UNITED STATES PATENT AND TRADEMARK OFFICE

APPLICATION NO.	FILING DATE	FIRST NAMED INVENTOR	ATTORNEY DOCKET NO.	CONFIRMATION NO.
09/681,674	05/18/2001	Yoshifumi Natsuyama	JP920000096US1	3666
7590 11/29/2004			EXAMINER	
ANNE V. DOUGHERTY, ESQ. 3173 CEDAR ROAD YORKTOWN HEIGHTS, NY 10598			RUDE, TIMOTHY L	
			ART UNIT	PAPER NUMBER
			2883

Office Action Summary

DETAILED ACTION

Figure 11

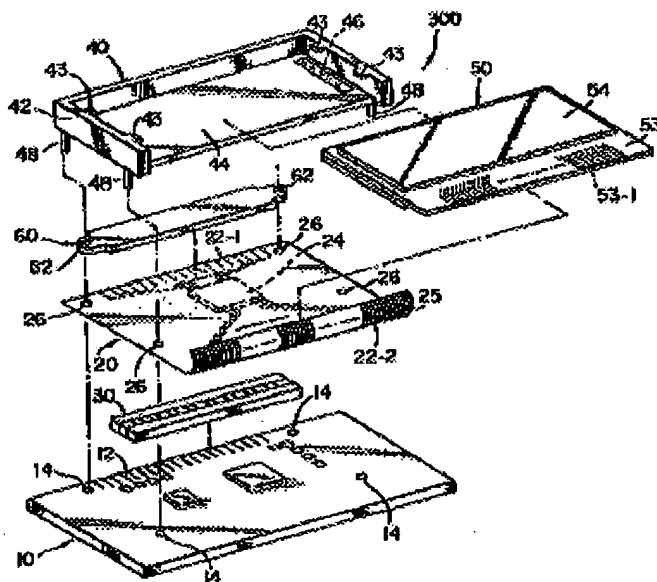
As to claim 4, Muramatsu discloses in his third embodiment, [Figures 11 and 12, col. 10 line 66 through col. 13, line 6] a liquid crystal display panel comprising: a pair of glass substrates facing each other, each having electrodes for applying voltage to a liquid crystal material on a facing surface (typical); a circuit board, 10, for supplying said voltage; and a liquid crystal driver tape carrier package, [20, col. 11, lines 7-9 and col. 7, lines 1-3] for connecting said electrodes of said glass substrates to said circuit board and mounting a liquid crystal driver chip [col. 11, lines 7-9 and col. 7, lines 4-13], wherein said liquid crystal driver tape carrier package and said circuit board each have more than two anchor holes, [four of 26 and 14 respectively], and anchor pins, 48, are inserted into said anchor holes, whereby said liquid crystal tape carrier package is fixed to said circuit board [col. 11, lines 45-48], wherein said anchor holes are located in a path region of substantial propagation of stress resulting from a difference in coefficients of linear expansion between said glass substrates and said circuit board, and more than two anchor pins, 48, are inserted, one pin into each of said more than two anchor holes.

Muramatsu does not explicitly disclose a display wherein said liquid crystal driver tape carrier package is soldered to said circuit board via said pins.

As to claim 6, Muramatsu discloses the liquid crystal display device wherein a pair of said anchor holes, 26, is located with said liquid crystal driver chip, 24, between [diagonally per Figure 11].
